# Replace Front Body Controller Module Thermal Harness Cover

<b>Classification</b>	Campaign Bulletin	<b>Section/Group</b>	17 - Electrical	<b>Country/Region</b>	North America
<b>Year</b>	2017	<b>Model</b>	Model 3	<b>Version</b>	All

**Figure 1**

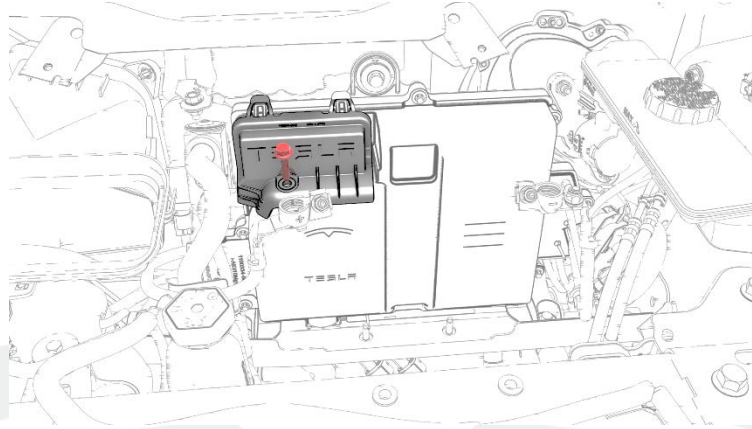
Certain Model 3 vehicles have thermal harness covers that might allow splashed water to ingress into the front body controller module, potentially resulting in diminished connection.

2. Remove the bolt that secures the thermal harness cover to the front body controller module (Figure 1).

Install an improved front body controller module thermal harness cover.

3. Release the clips (x2) that secure the top of the cover to the controller module, and remove and discard the cover.
4. Install the improved thermal harness cover onto the front body controller module, and fasten the clips at the top of the cover.
5. Install the bolt that secures the cover to the controller module (torque 6 Nm) (Figure 1).
6. Install the cabin intake duct (refer to Service Manual procedure 18108402).
